Technical Service Bulletin

94 Headlight moisture accumulation

94 12 89 2030960/1 September 25, 2012.

Model(s)	Year	VIN Range	Vehicle-Specific Equipment
A8	2011	All	Not Applicable
	2012		
	2013	000001 – 008813

Figure 3. Illustration of the ventilation components.

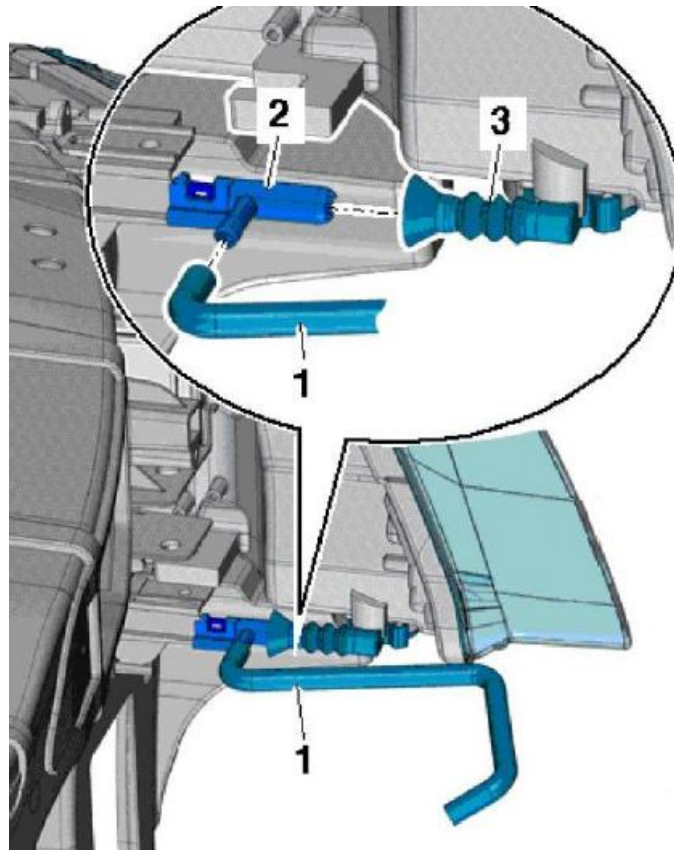
2. Replace the ventilation hose (Figure 3, 1) and adapter (Figure 3, 3) on both sides and attach it to the mounting (Figure 3, 2). Use the part numbers indicated in the Parts table below.

3. It is not necessary to use the membrane from the original adapter.

Figure 5. Illustration of the ventilation components.

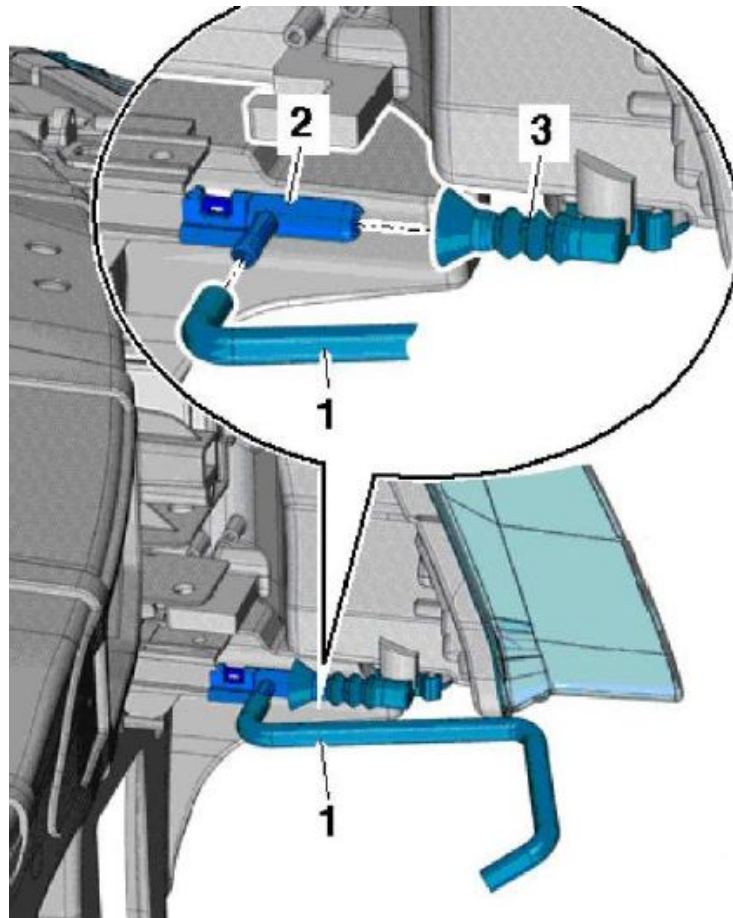
1. Remove and dry out the headlight(s) with compressed air (less than 30 PSI).
2. Replace the ventilation hose (Figure 5, 1) on both sides and attach it to the mounting (Figure 5, 2). Use the part numbers indicated in the Parts table below.
